**ADDENDUM NO. 1**

**AUTOMATED PEOPLE MOVER OPERATING SYSTEM  
SUPPLIER ELIGIBILITY DETERMINATION**

**LANDSIDE ACCESS MODERNIZATION PROGRAM**

**LOS ANGELES INTERNATIONAL AIRPORT**

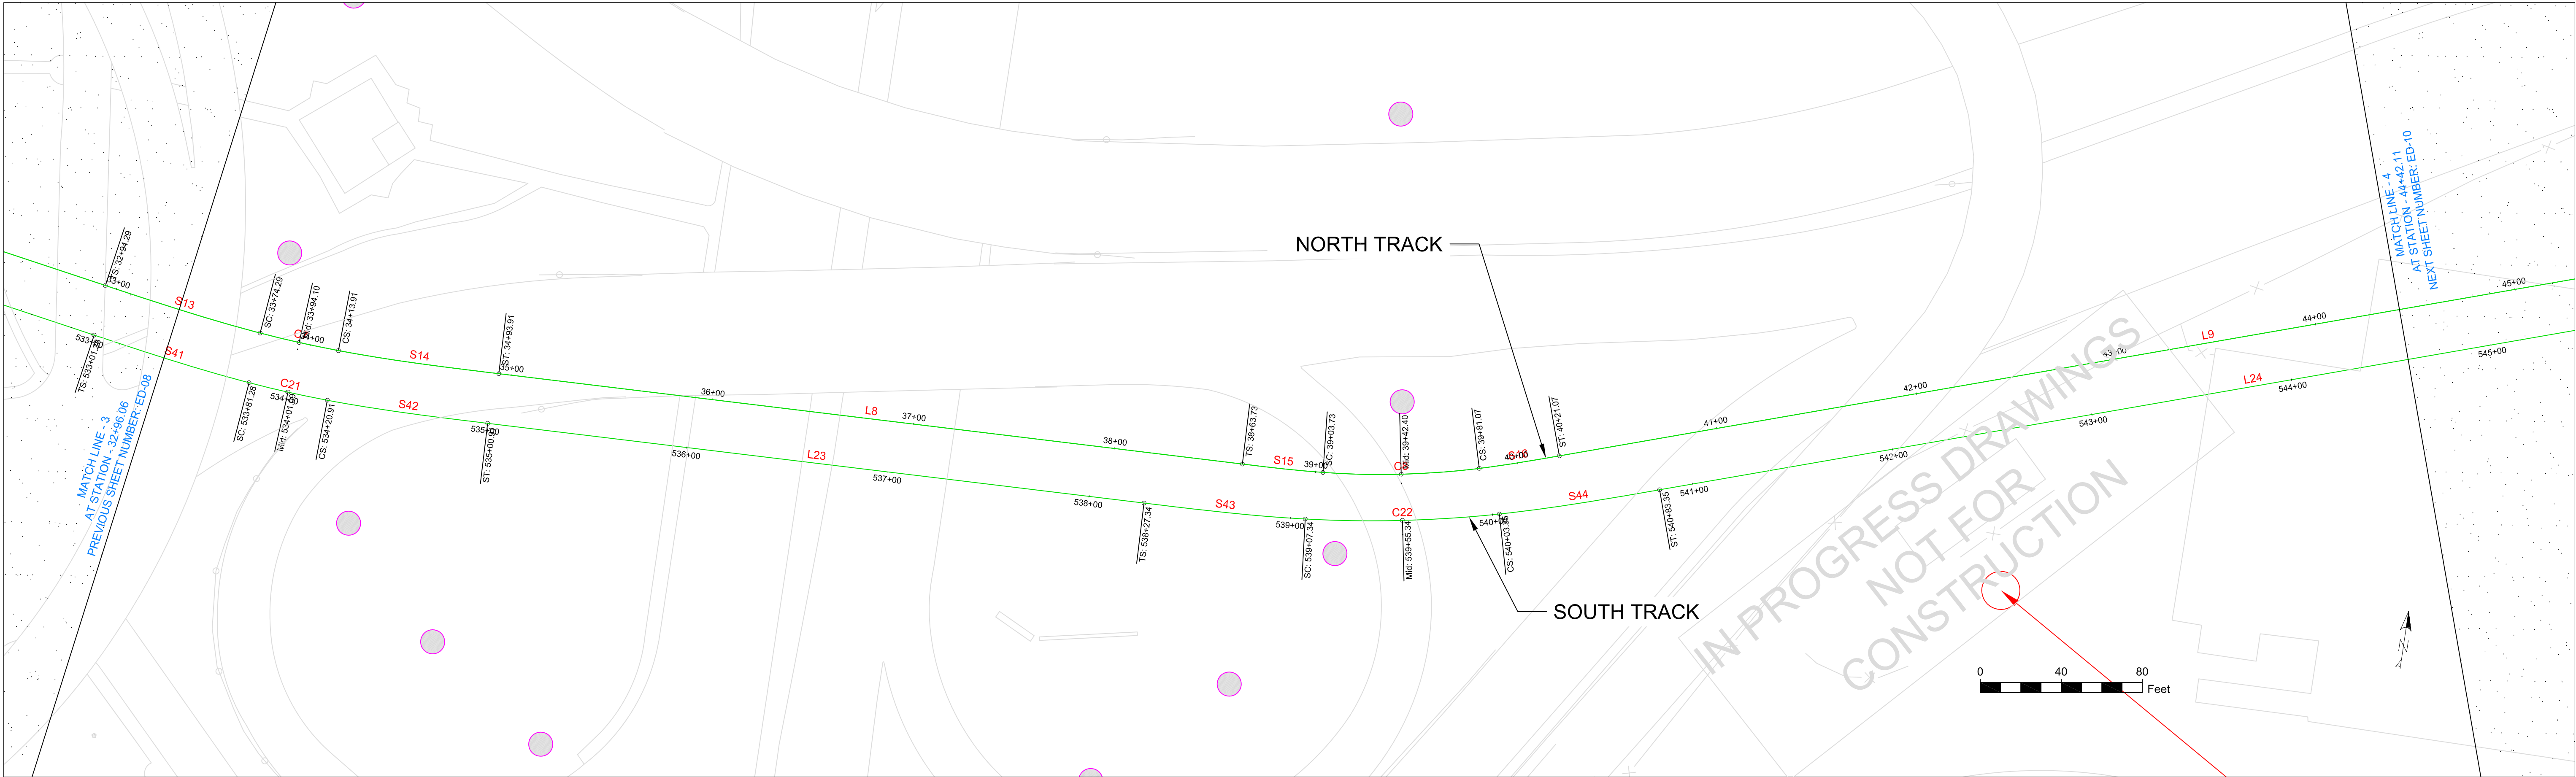
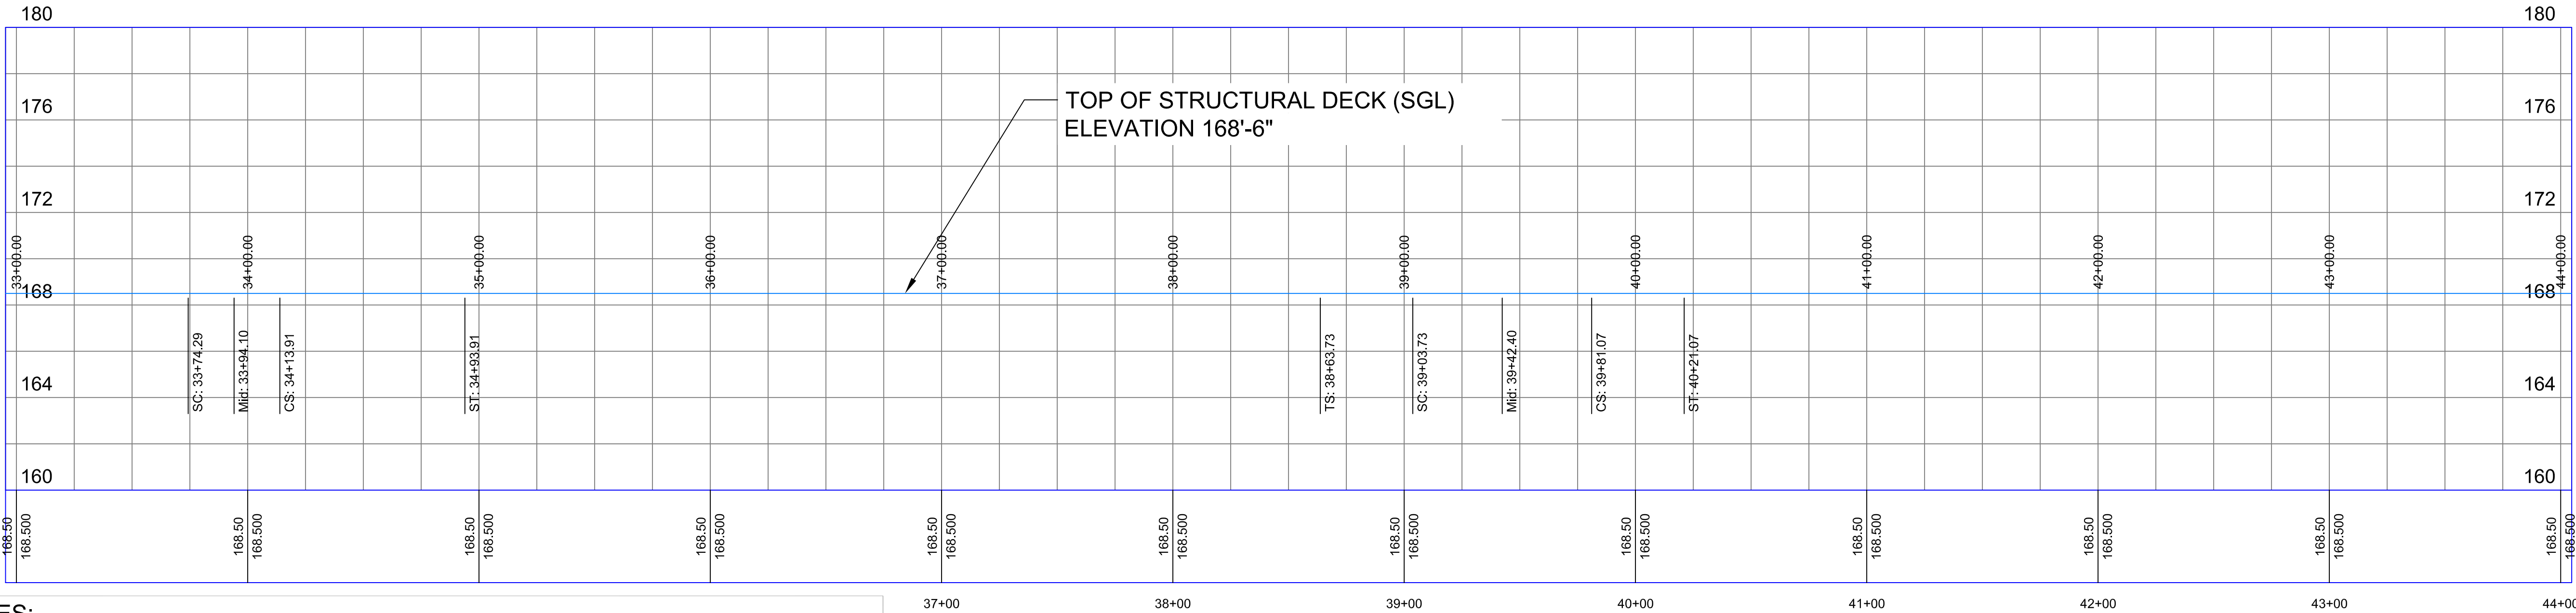
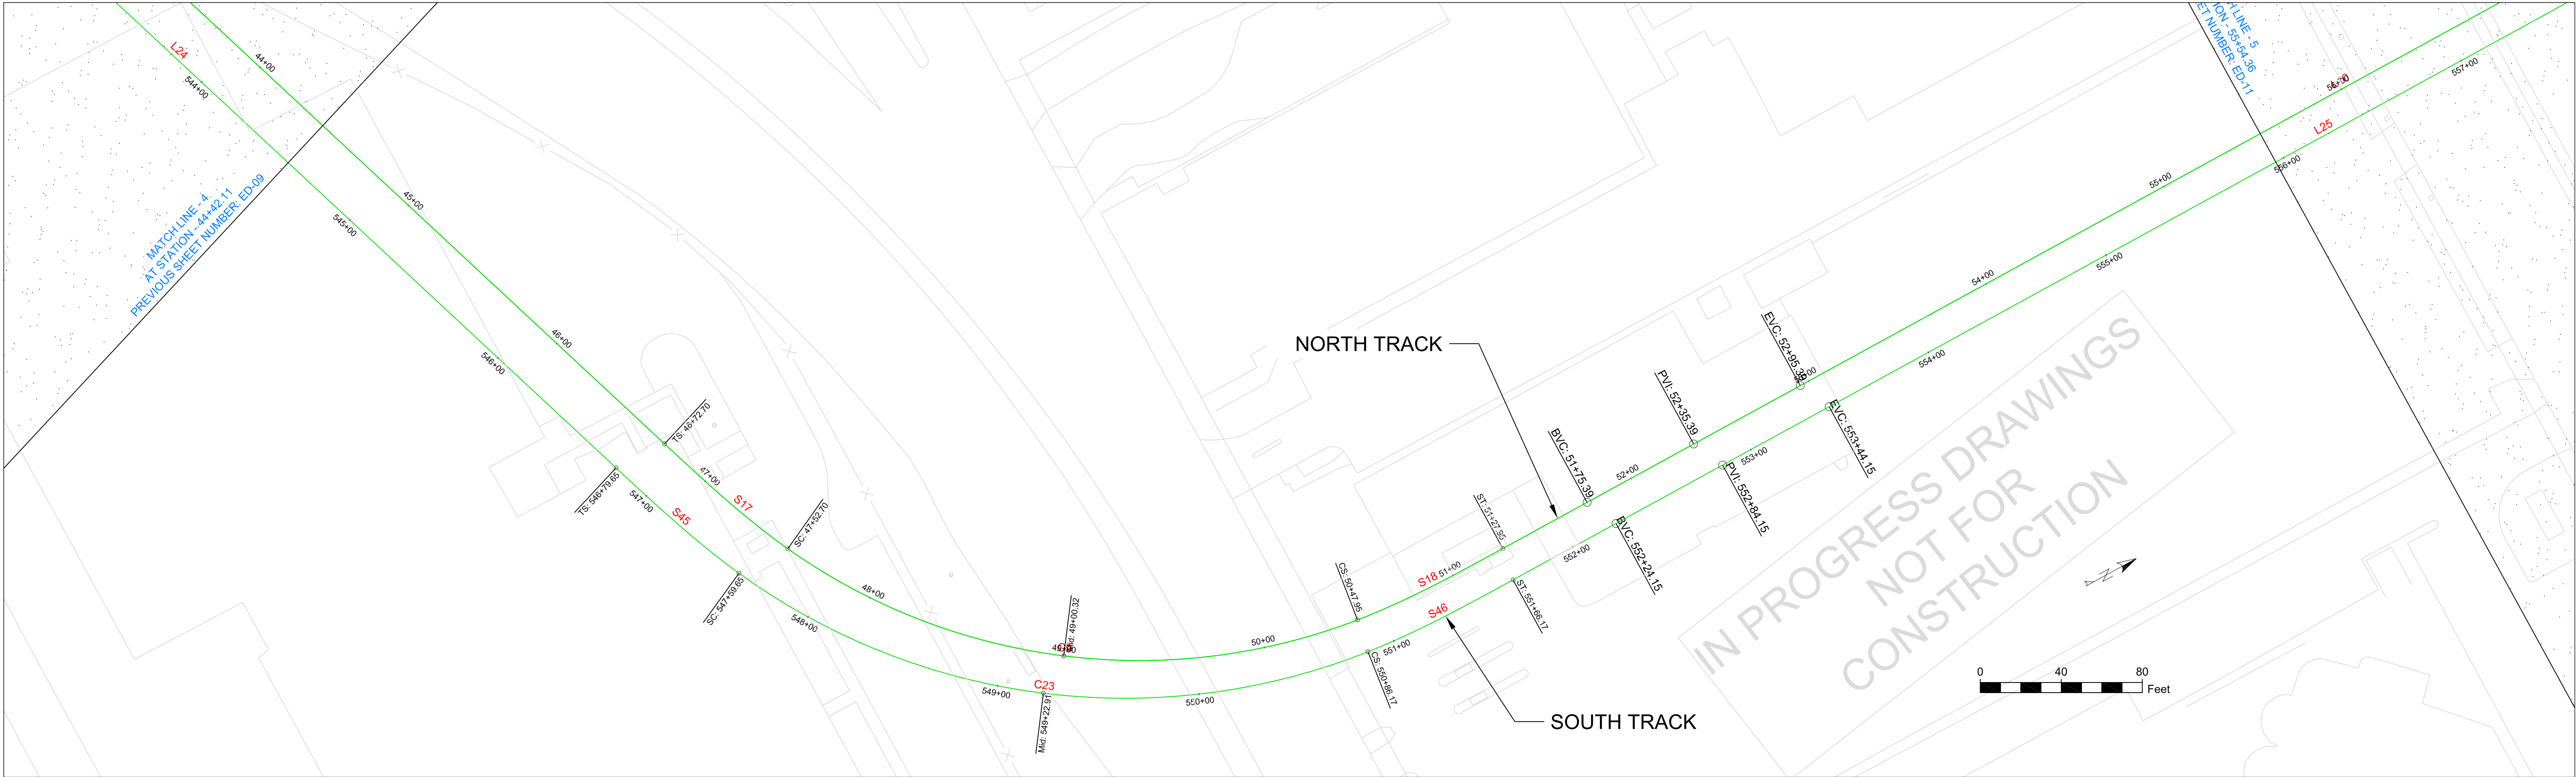
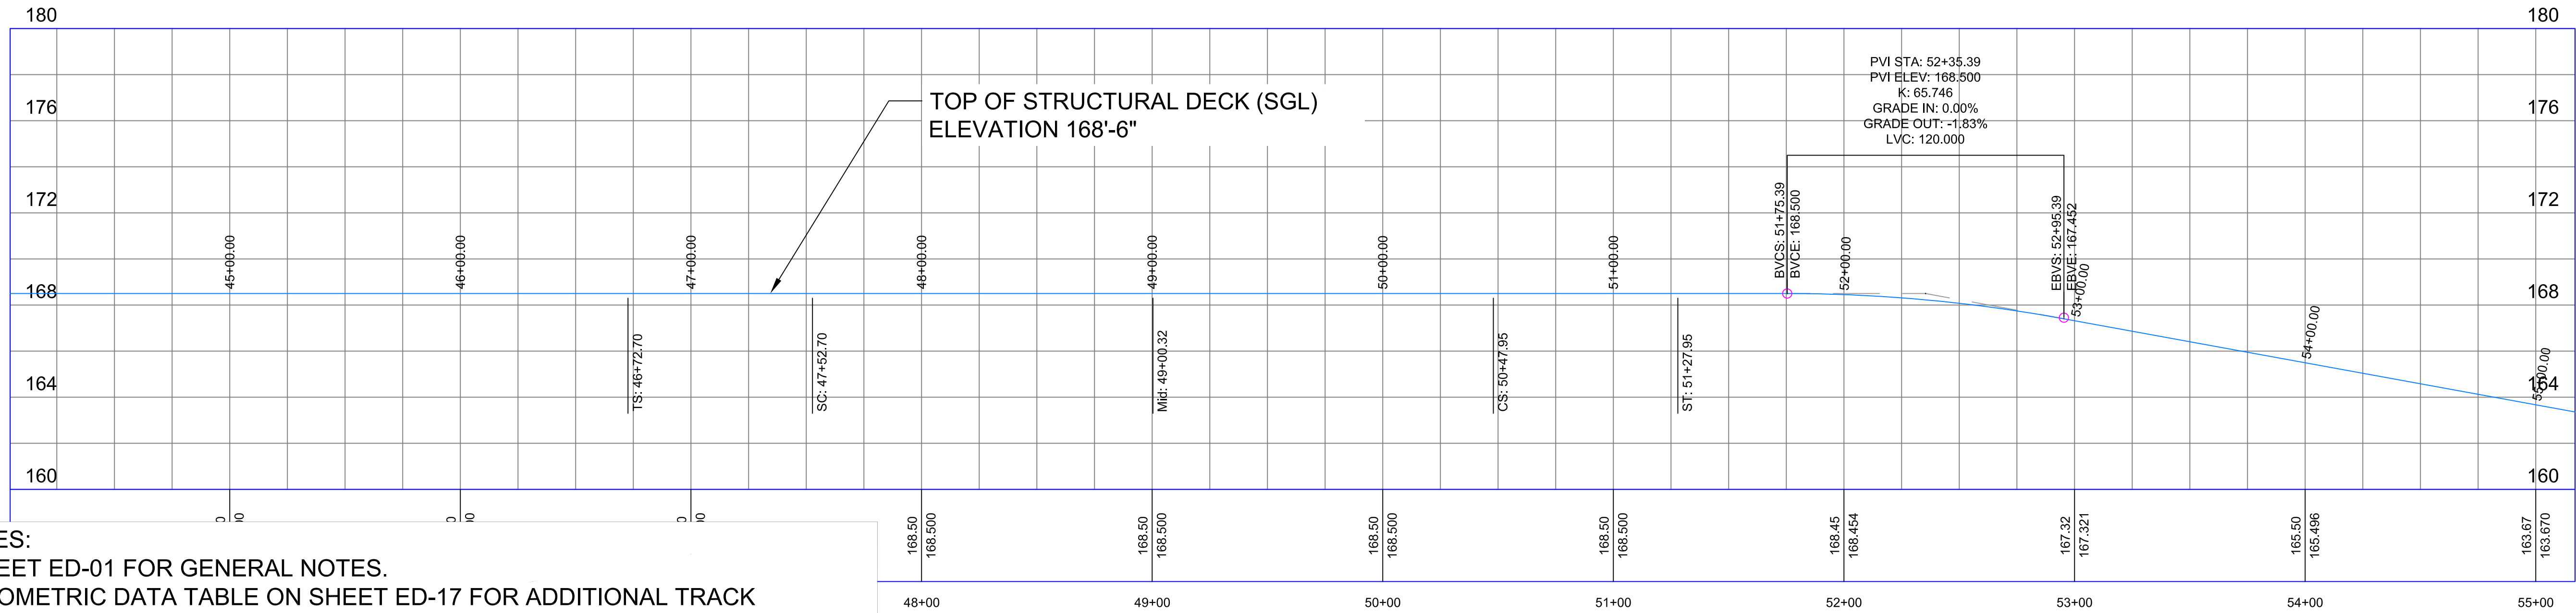
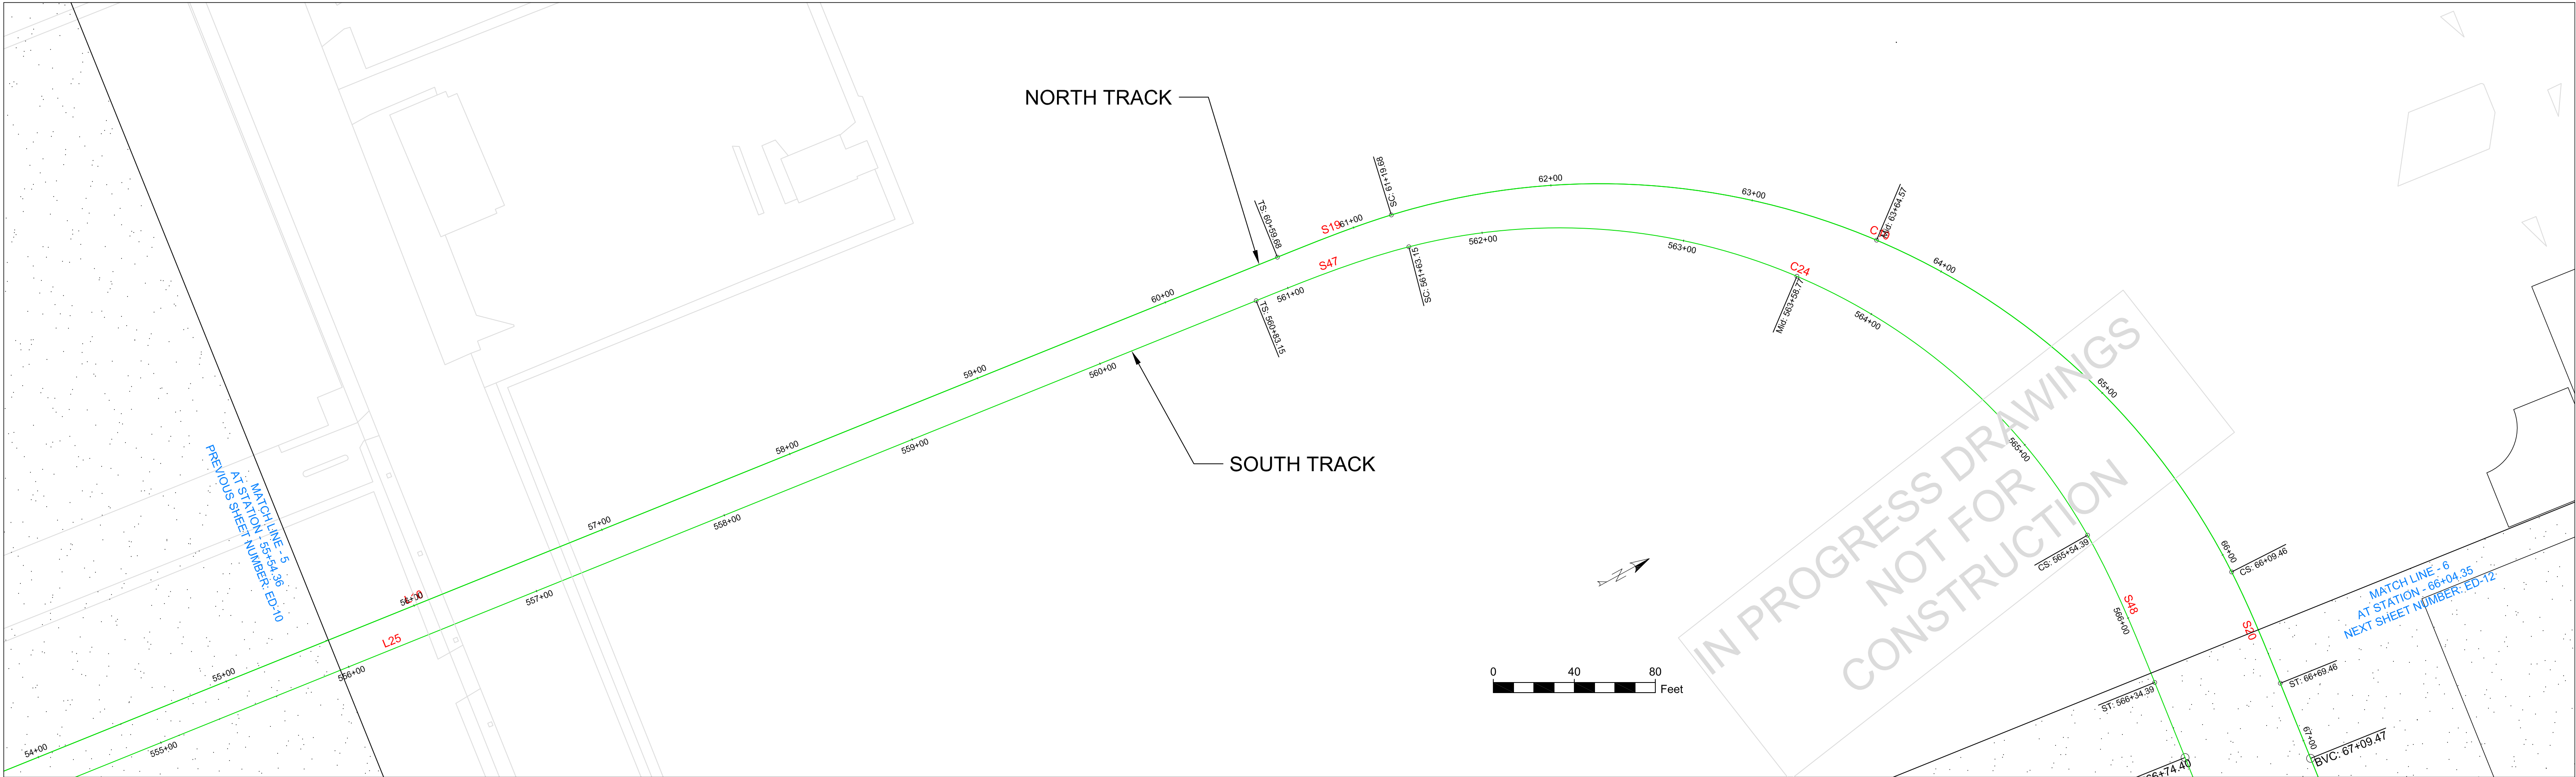
**RFC 5 :** Attachment 4 – Sheets ED-17 and ED-18. We reviewed and re-created the alignment stationing and find that there is a discrepancy between the alignment stationing (created from the curve data) and the alignment stationing shown on sheets ED-09 through ED-16. A similar discrepancy is observed on Sheets ED-03 through ED-05. Please clarify.

- a. Replace sheets ED-04, ED-05, ED-09 through ED-16, and ED-19 with attached sheets ED-04, ED-05, ED-09 through ED-16, and ED-19, Addendum 1 – May 5, 2016. Revised sheets incorporate a correction to the stationing on the sheets.

**RESPONSE 5:** Refer to the revised Sheets ED-04, ED-05, ED-09 through ED-16, and ED-19 for Attachment 4 in Addendum 1 – May 5, 2016.
